DATE ISSUED September 26, 2014

ADDENDUM # 2

PROJECT LPS Security/Technology Ready Facilities – Project F

ETI PROJECT # 2014-028

CAMERA POLE CABINET DETAIL

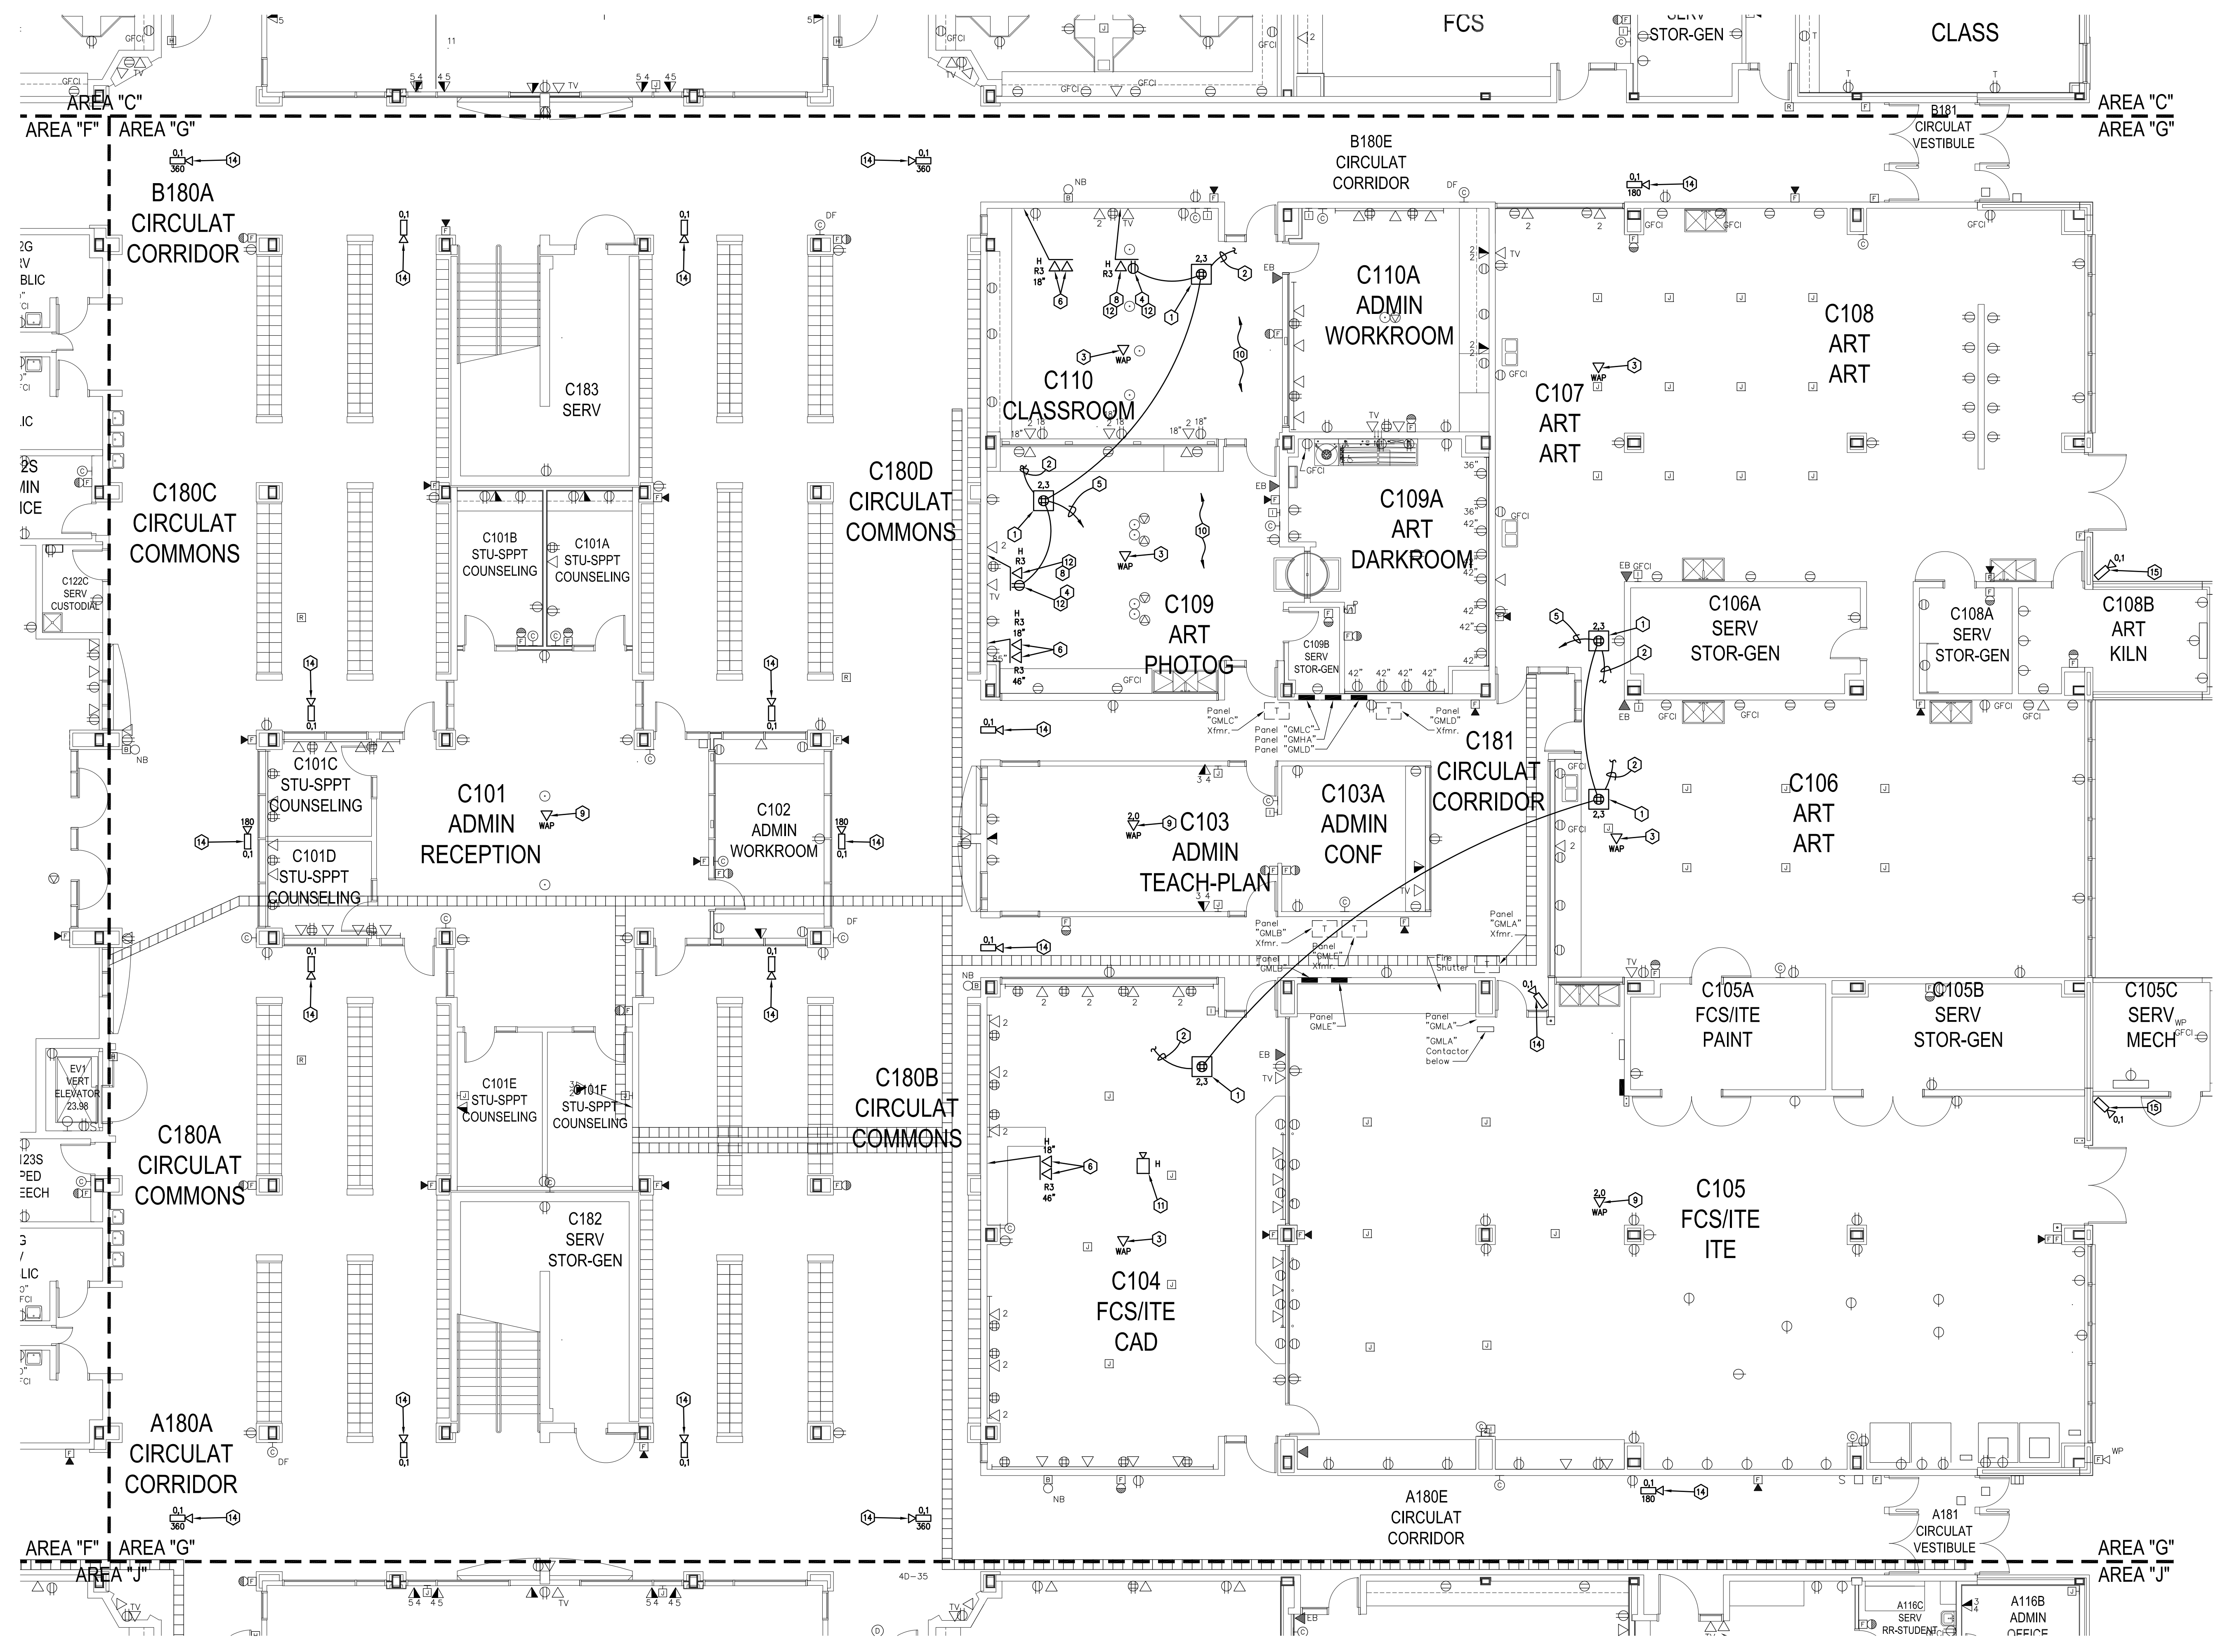
- C. See attached details for camera pole and camera pole cabinet.

306.T02G

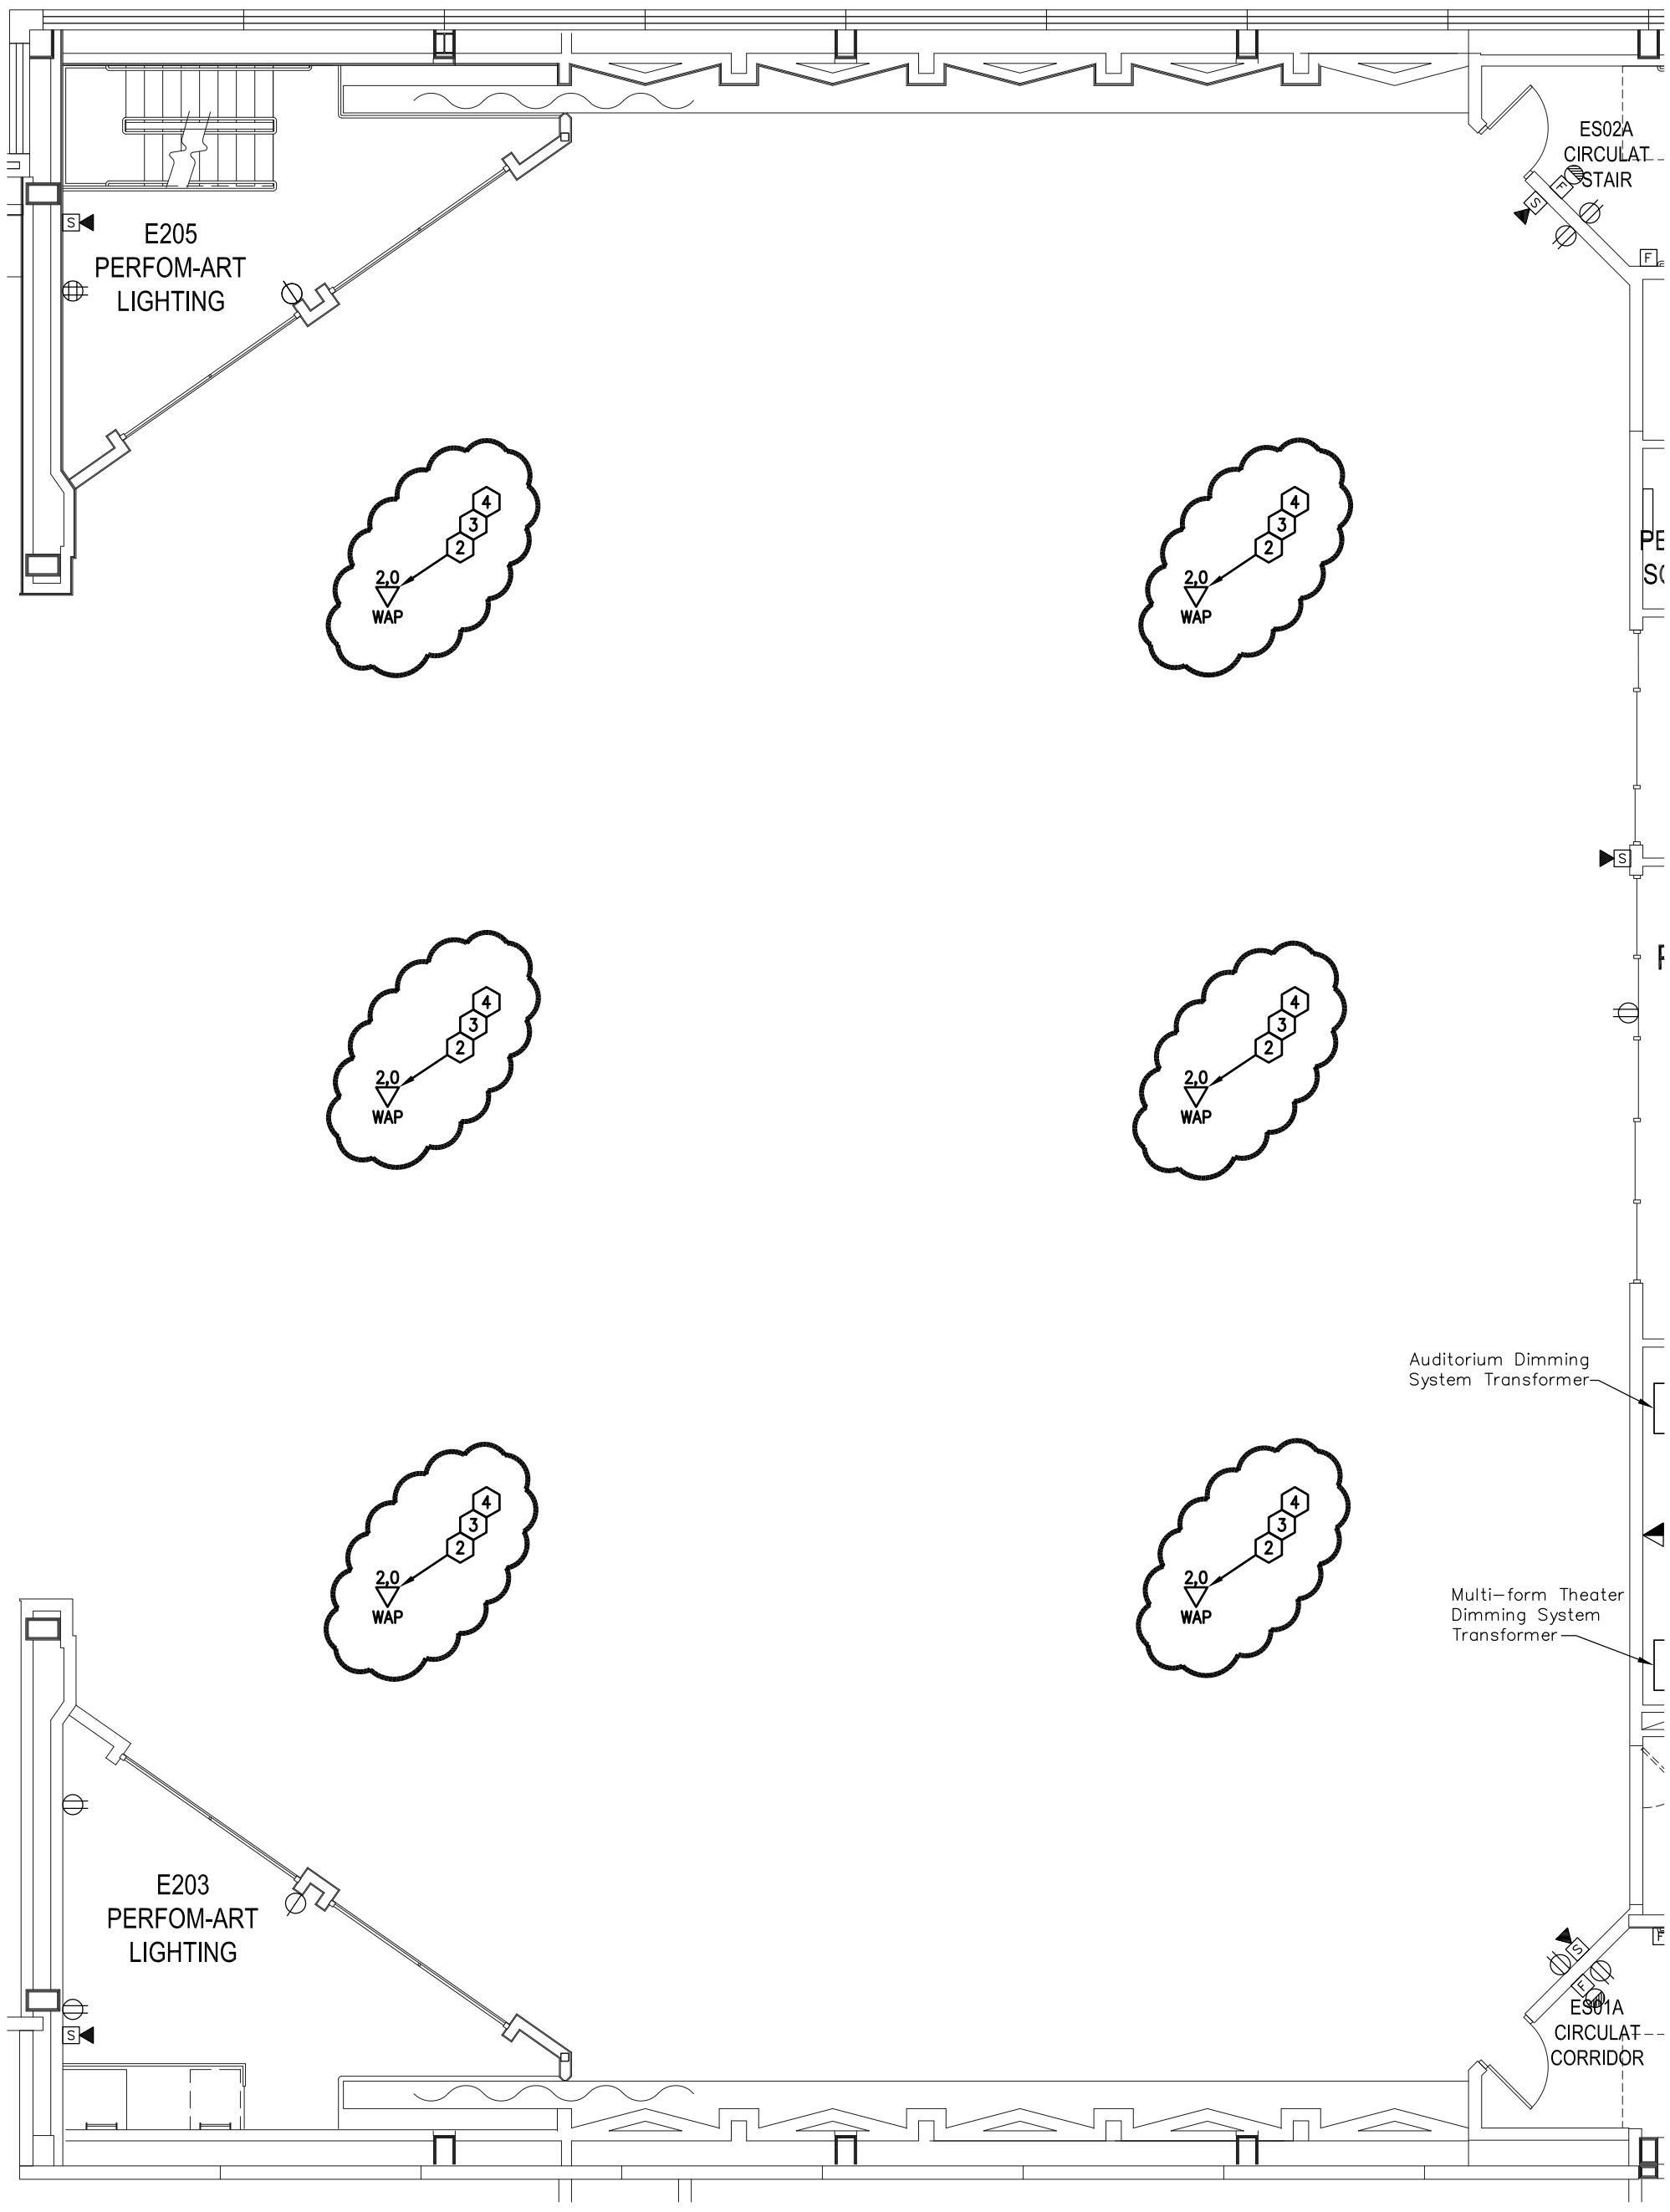
4. Sheet 306.T02D – The gym WAP's should indicate 2,0.
5. Sheet 306.T02G – is missing. See attached drawing.
6. Sheet 306.T03B
 - A. Relocate WAP from E200A to E200.

ADD #2
 SHEET
306.T03B
 ATTACHMENT NO.
 1
 09/26/2014

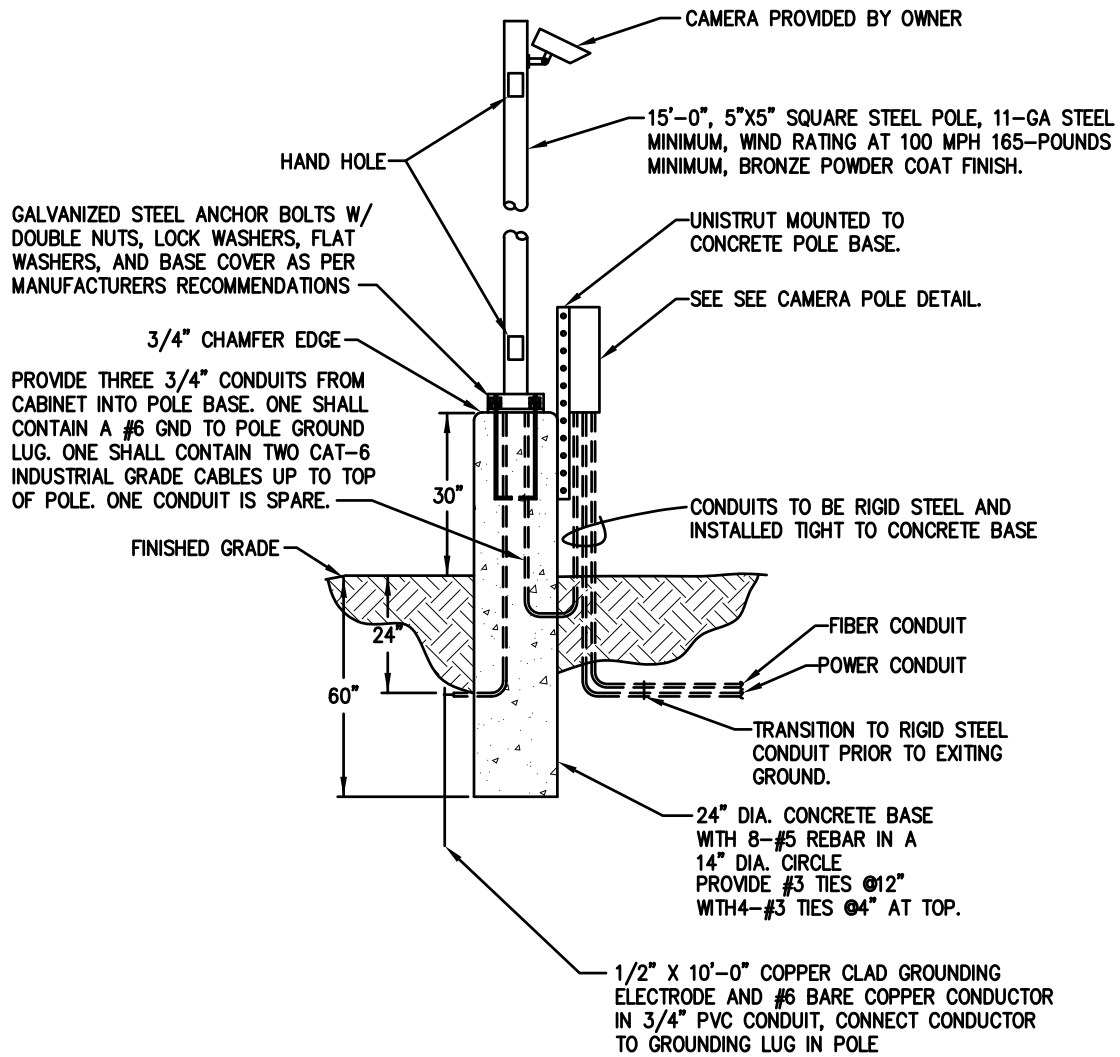
- B. See attached drawing for new layout of WAPS in Auditorium.
7. Sheet 306.T21
 - A. Detail P1 – The fiber enclosure required to house all of the fiber from Closet "A" will require 4RU so the Contractor shall move all other equipment down at least 4RU.

TYPICAL POLE MOUNTED CAMERA DETAIL

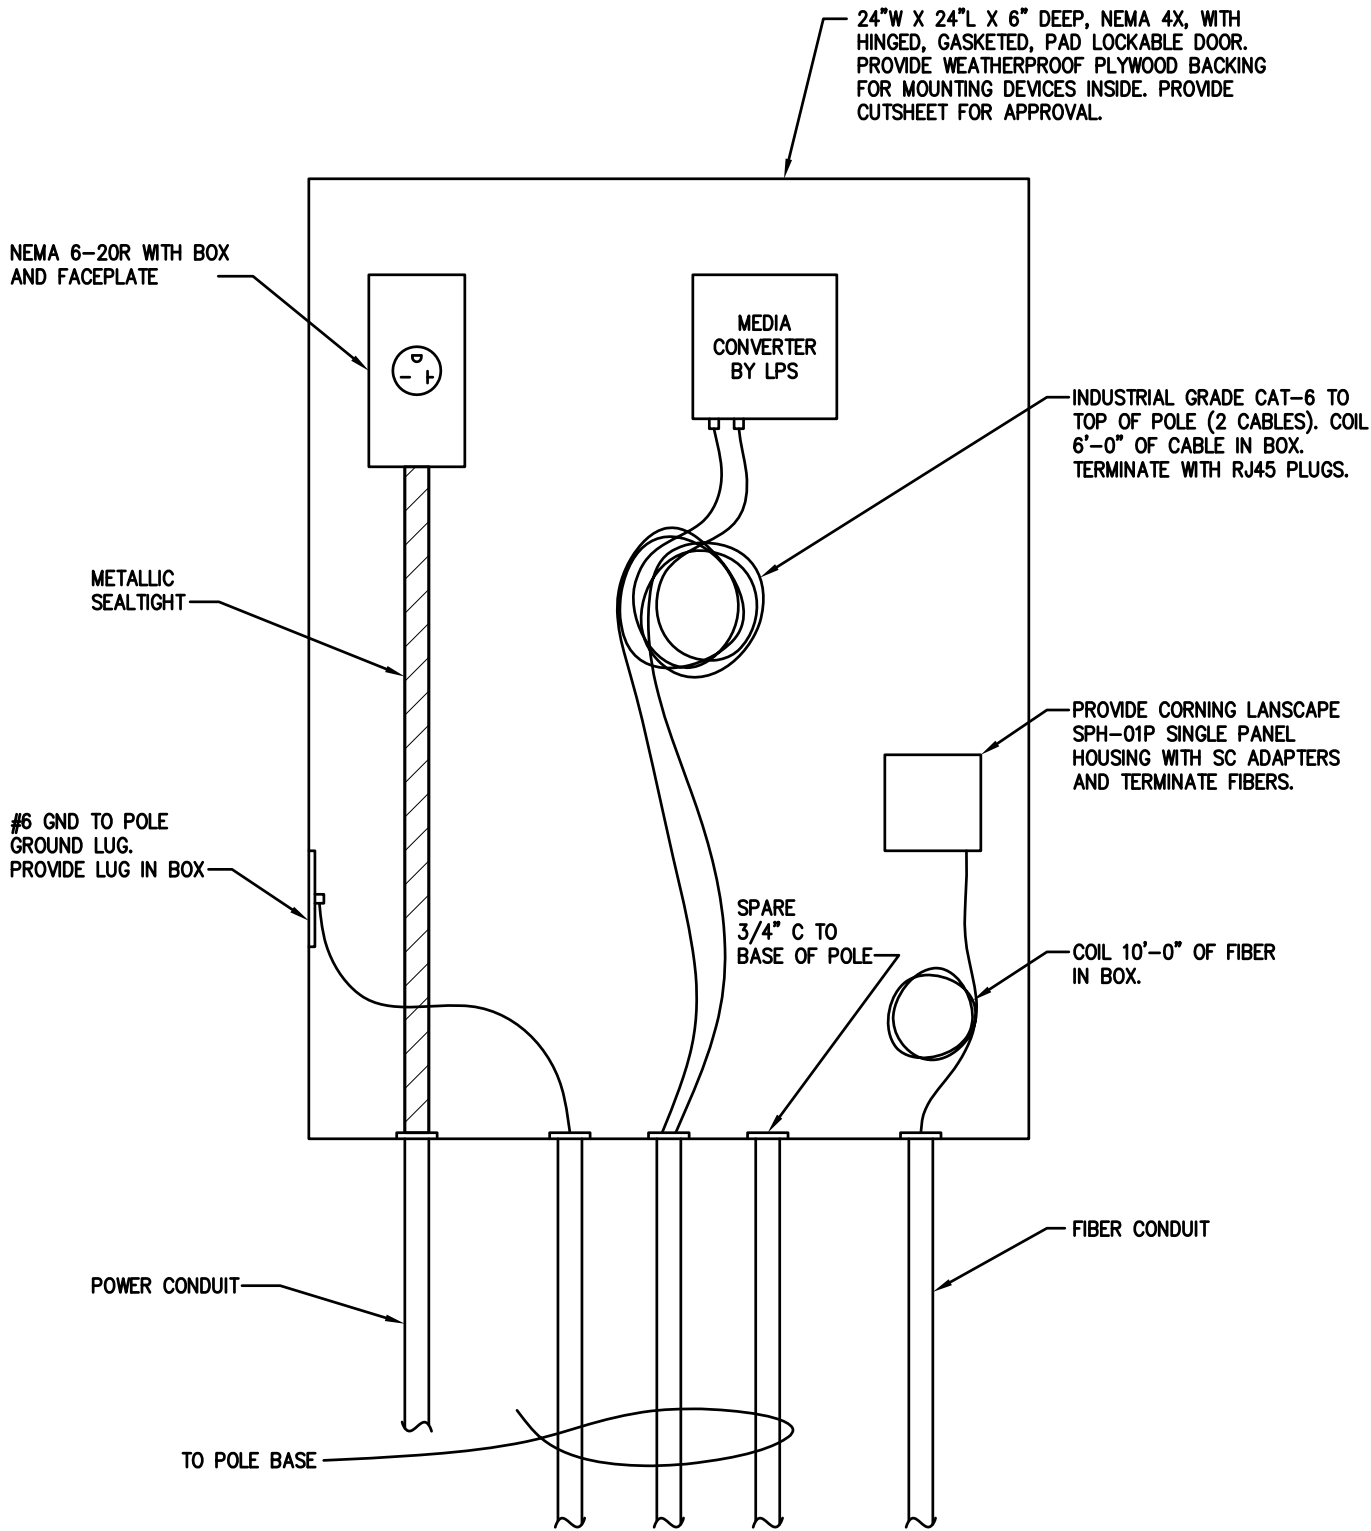
8. Sheet 306.TS00
 - A. The outside fiber cable indicated in Note 2 shall be rated Indoor/Outdoor cable OM3.
 - B. The circuits to the camera poles may be bored using Schedule 40 HDPE.

- C. See attached details for camera pole and camera pole cabinet.
